Value Engineering Study
***US 127 FROM KY 90 TO
JAMESTOWN BYPASS***
CLINTON & RUSSELL COUNTY, KENTUCKY

***ITEM NUMBER 8-108.00 & 8-115.10
VE STUDY NUMBER 201102***

Study Date: February 28 -
March 4, 2011

Final Report

VALUE ENGINEERING RECOMMENDATION # VE-14

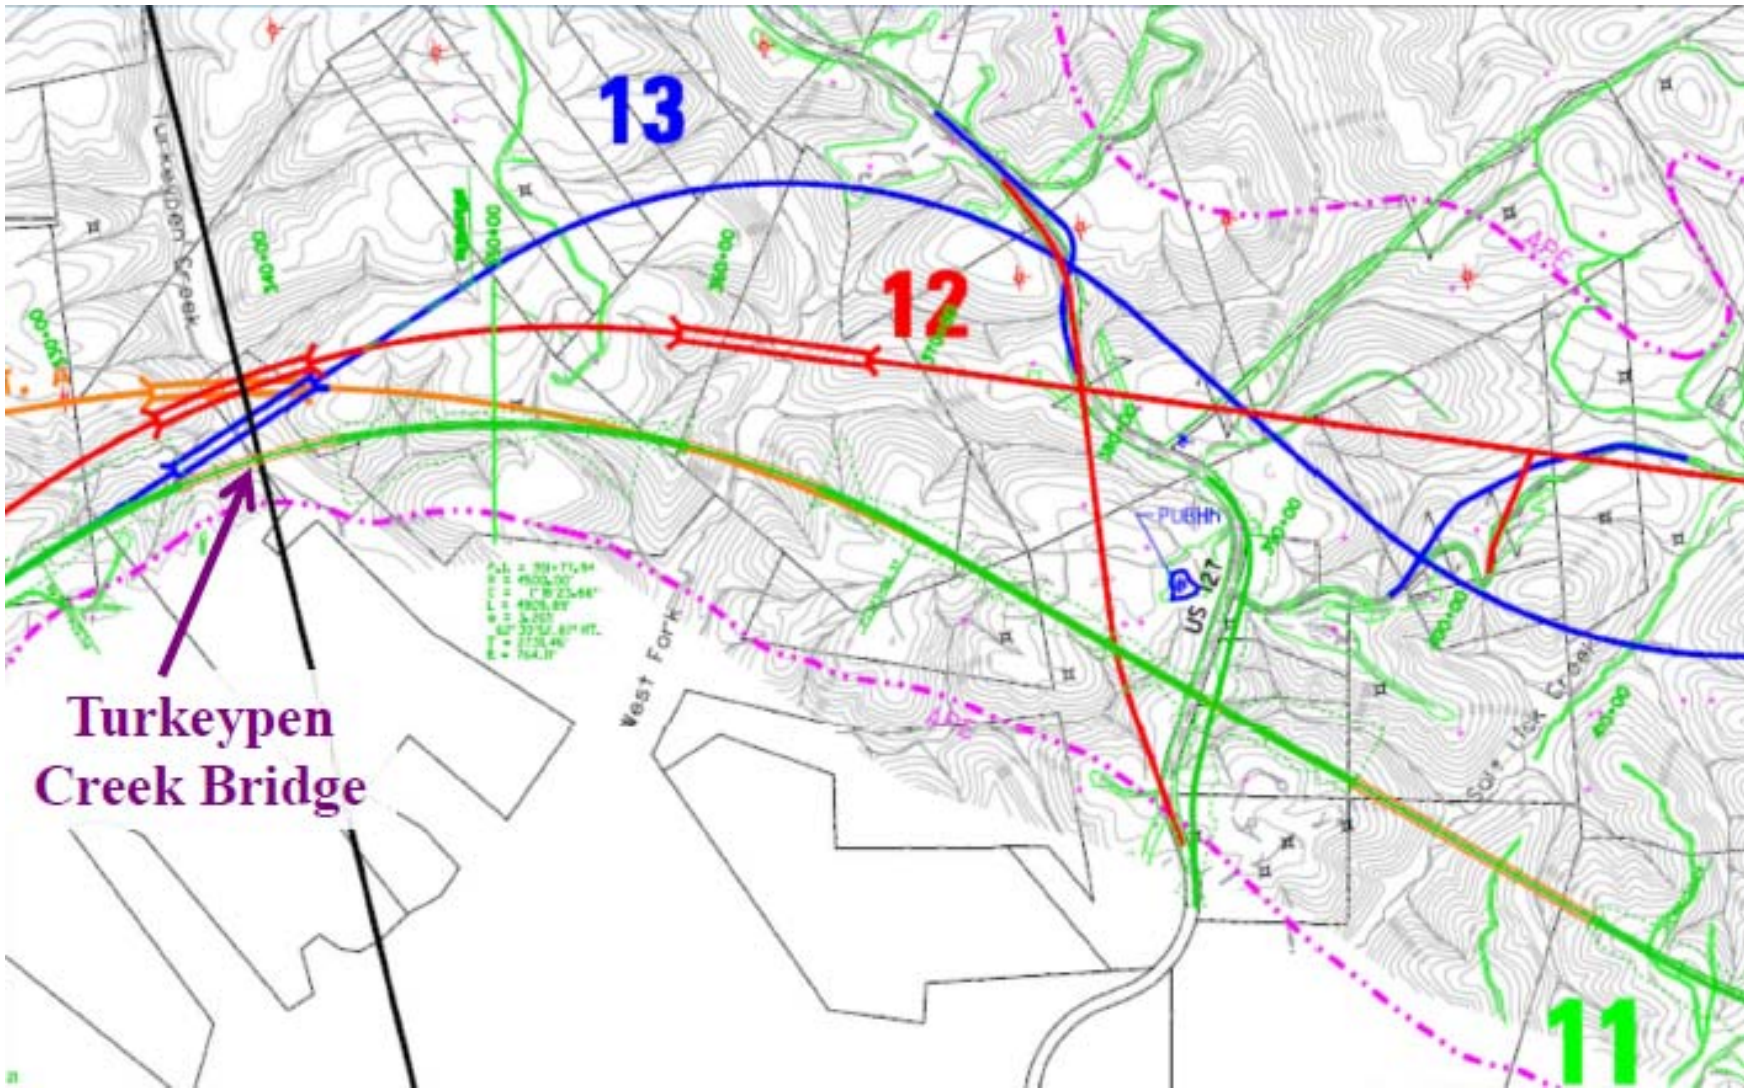
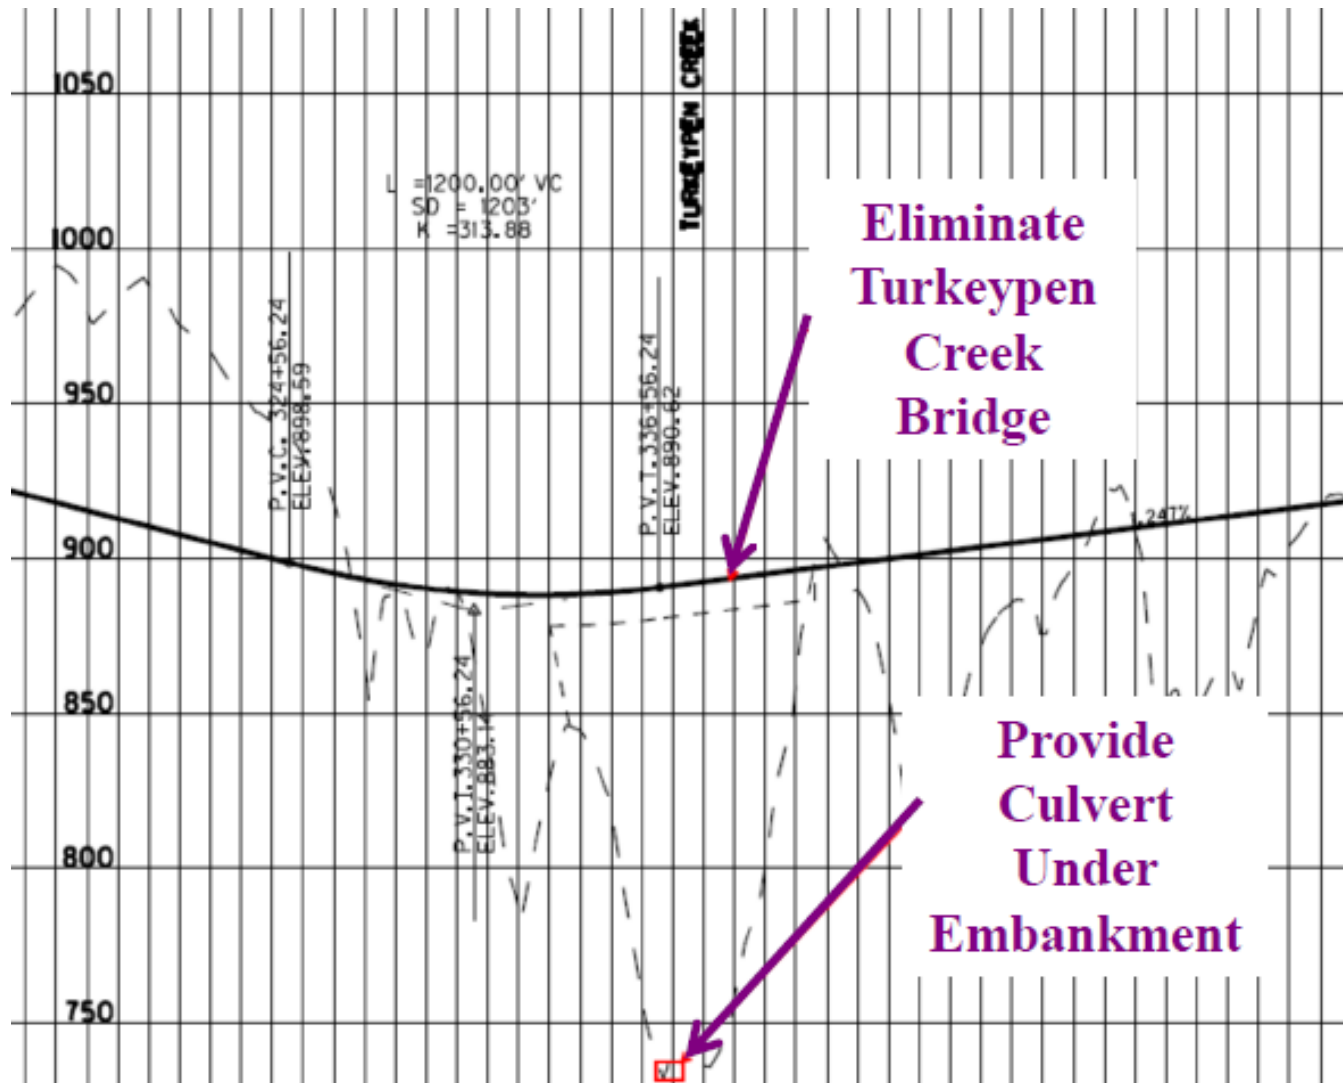
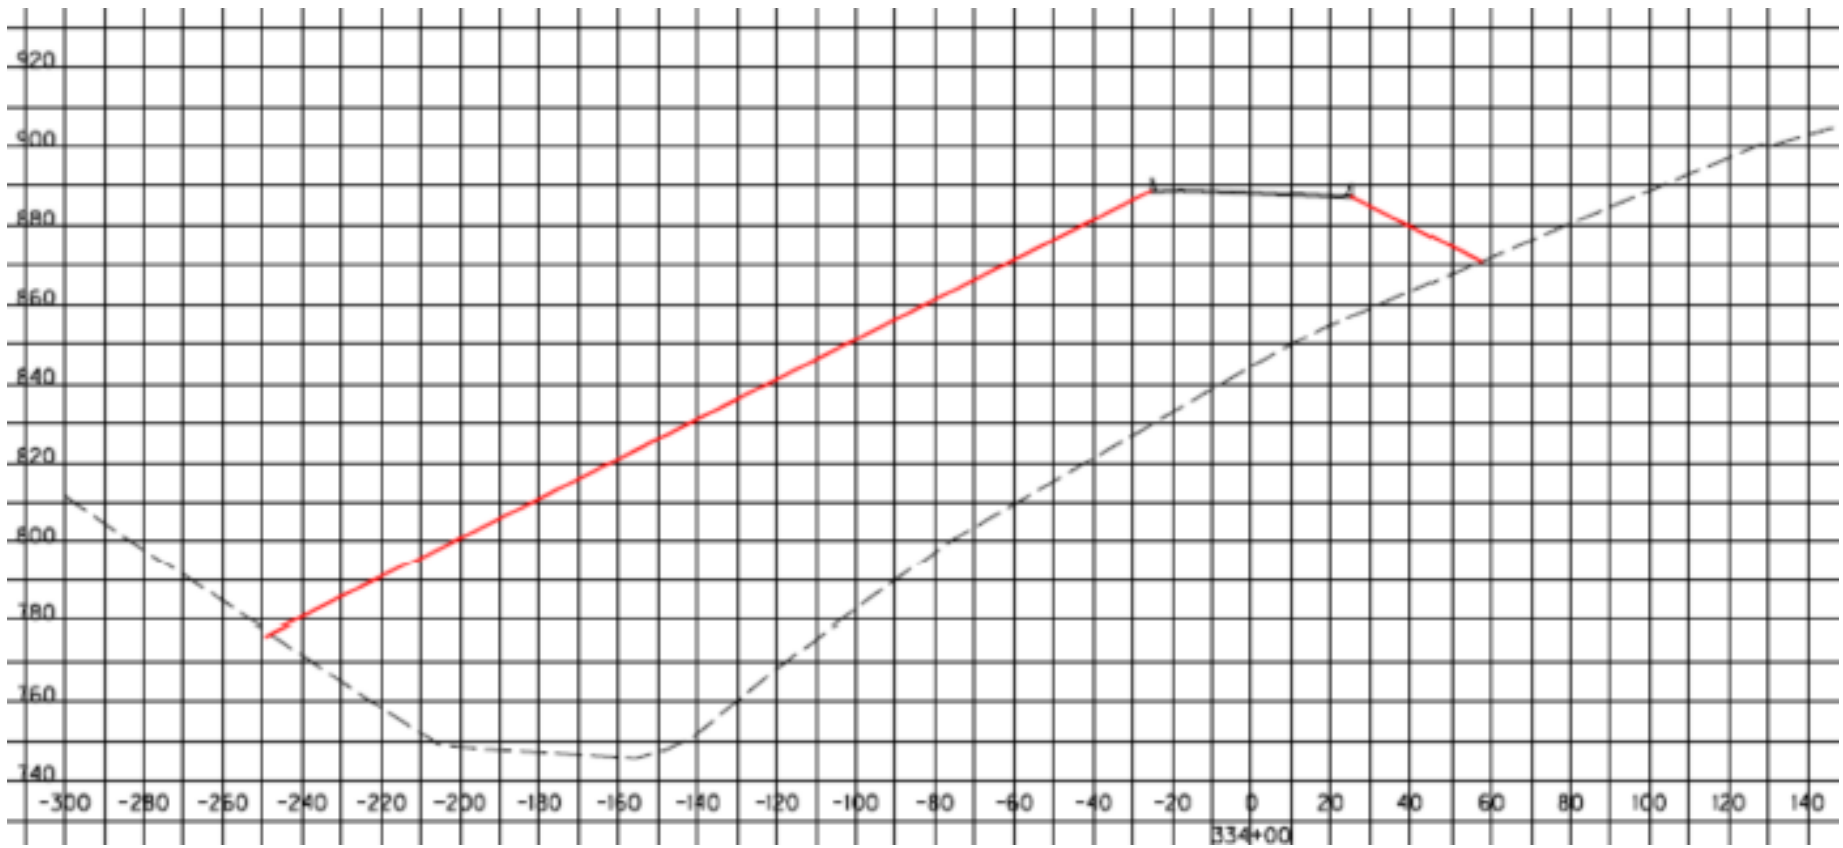
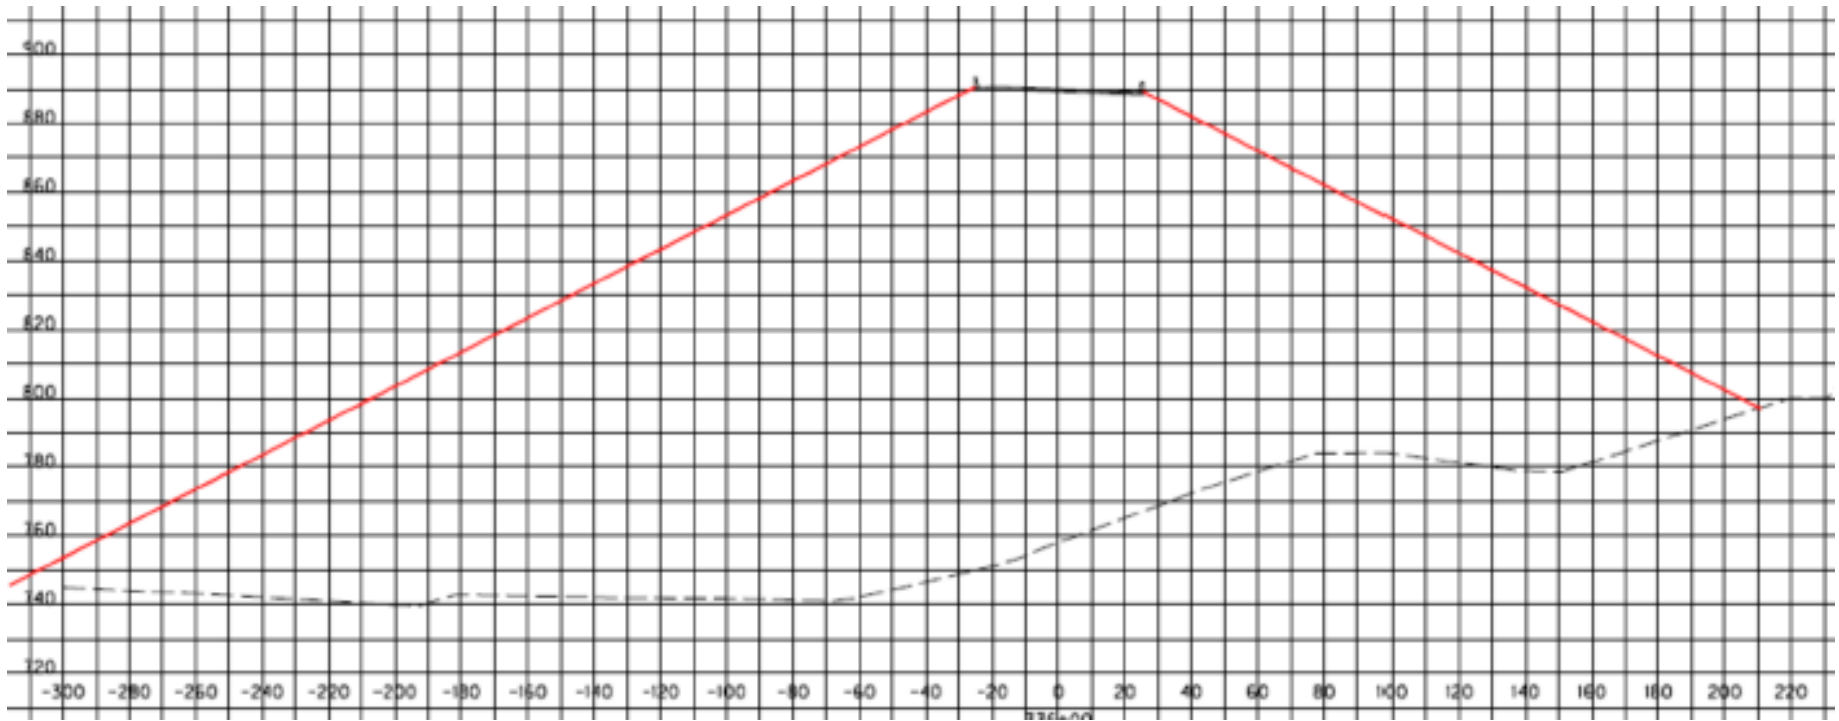
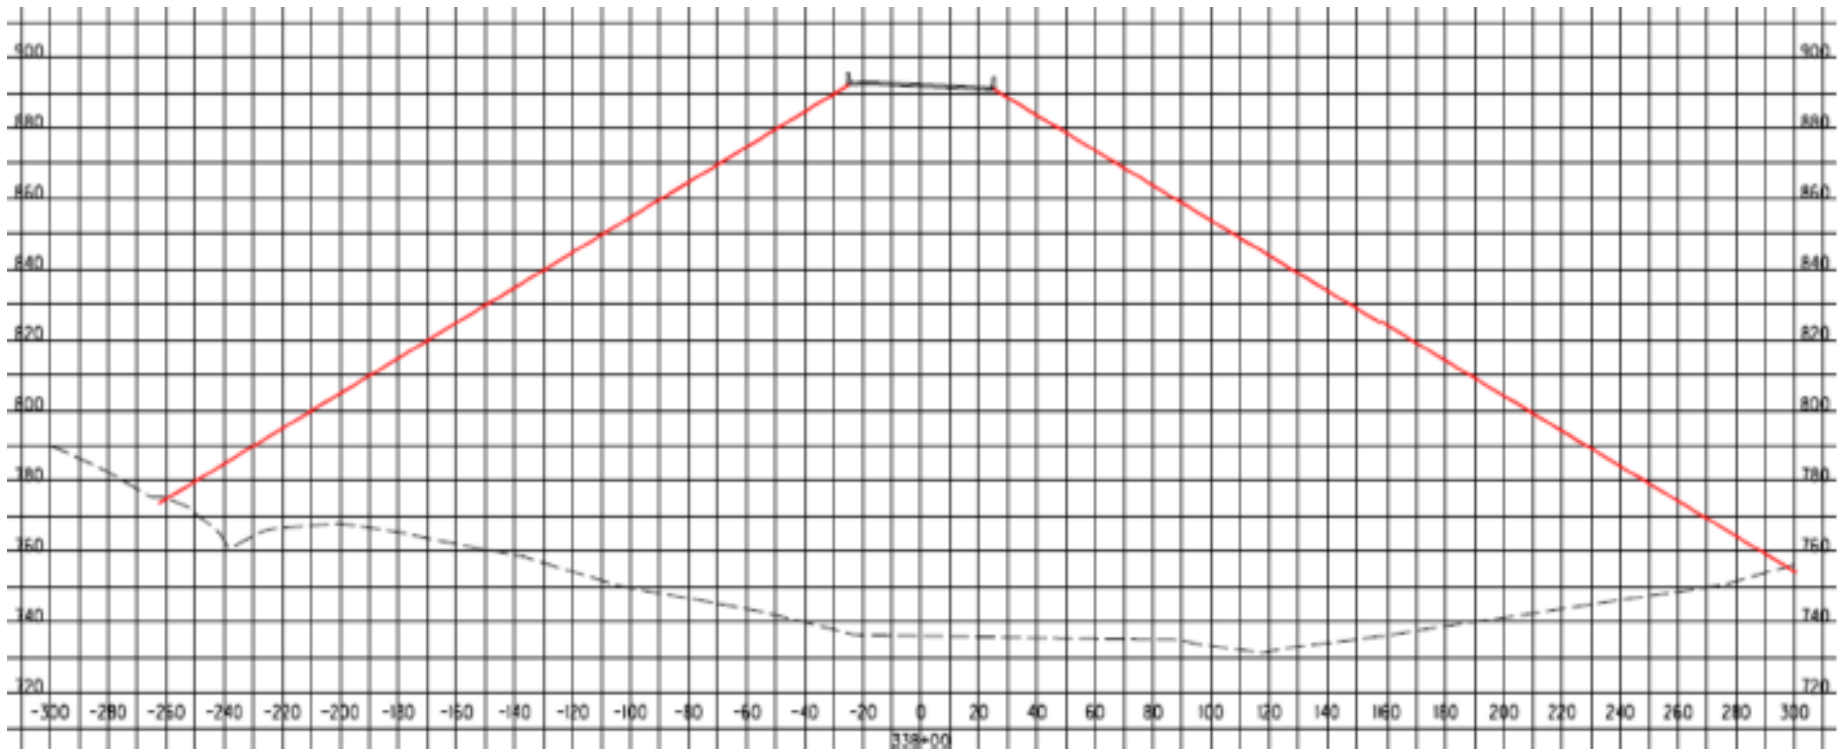
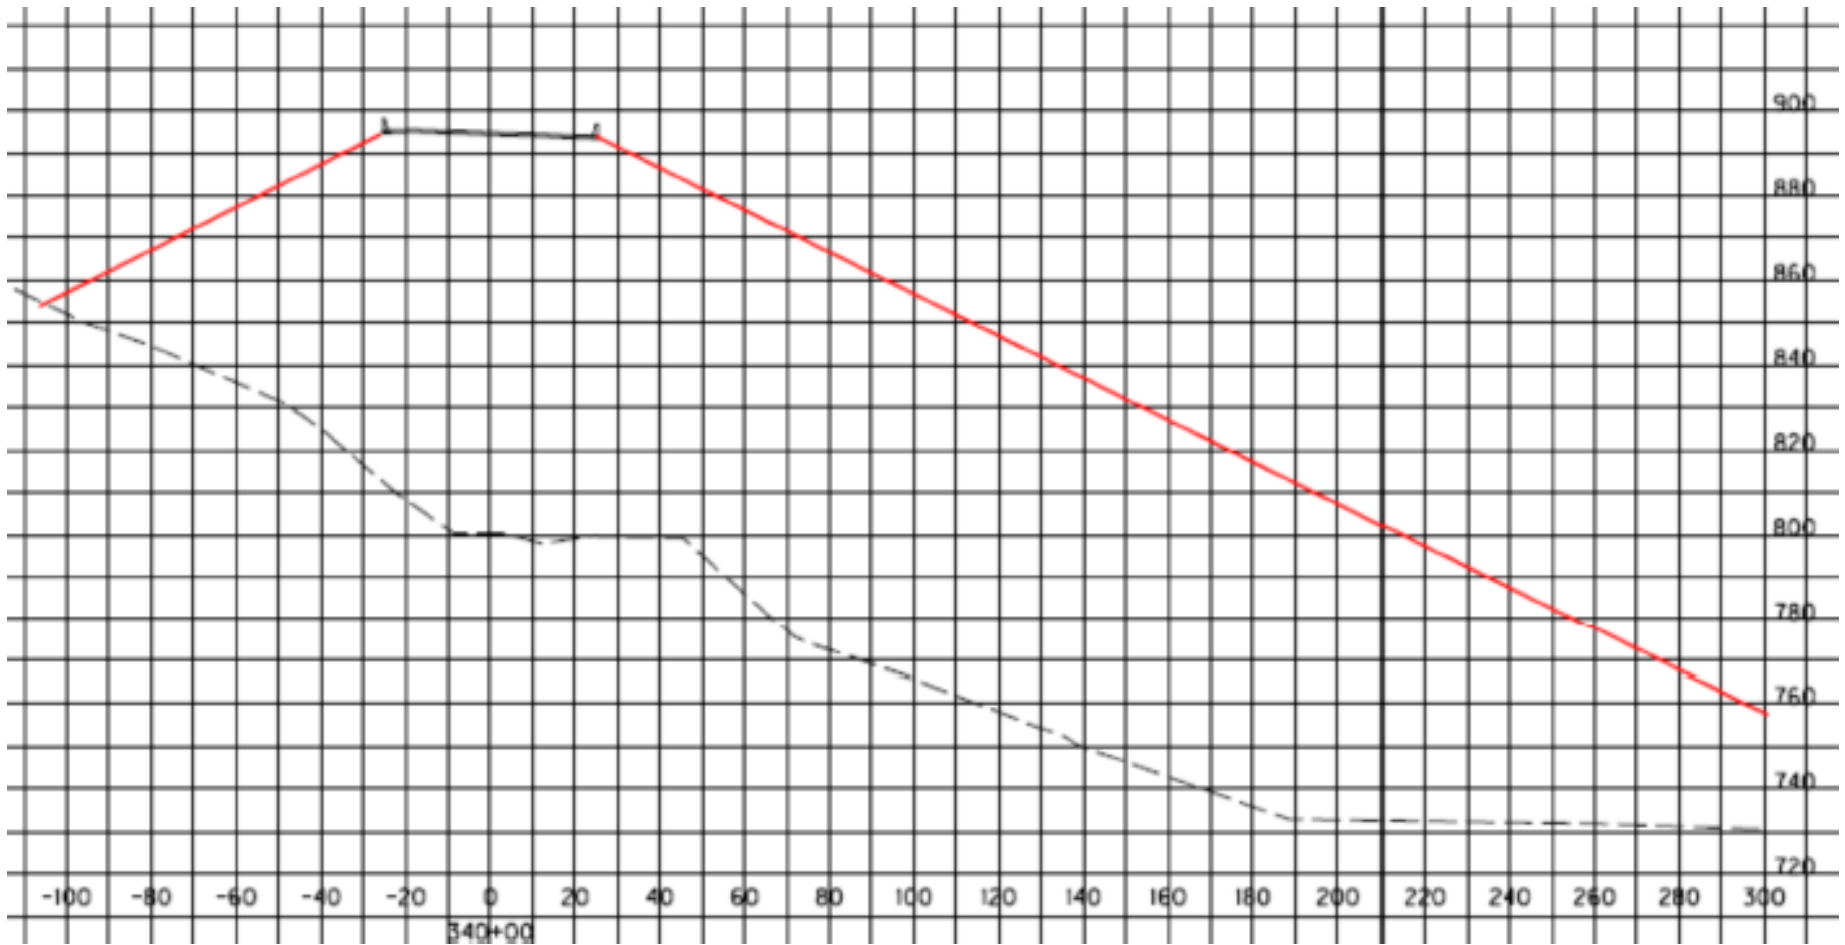
The original design specifies a bridge spanning Turkeypen Creek and the associated valley. Based on preliminary recommendations the estimated bridge length is 861 feet with a 51 foot bridge width. The valley at this location is approximately 150 feet below the profile grade for US 127. Based on the required pier height for this structure the VE team revised the project team’s square foot costs for the bridge to \$225 per square foot from \$105 per square foot to reflect the increased span lengths and complexity of constructing tall piers.

The original design estimated the bridge structure at \$105 per square foot. This bridge crosses a deep valley (approximately 150 ft from profile grade) and is located in a horizontal curve. Based on these items, the VE team is of the opinion that the true cost of the bridge structure will be closer to \$225 per square foot. This accounts for utilizing a longer span steel girders superstructure in lieu of precast and the added difficulty and cost of constructing tall piers in this terrain.

The revised initial construction costs are significantly reduced by eliminating the proposed structure in lieu of a culvert structure and embankment. A secondary benefit would be the elimination of future deck overlays/replacement, painting, and other bridge maintenance items. This VE proposal assumes a fill cost of \$6 per square foot. While not studied as part of this recommendation, adjusting the profile to reduce the depth of fills and better balance the overall cut fill for the project would increase the benefit of this VE recommendation.
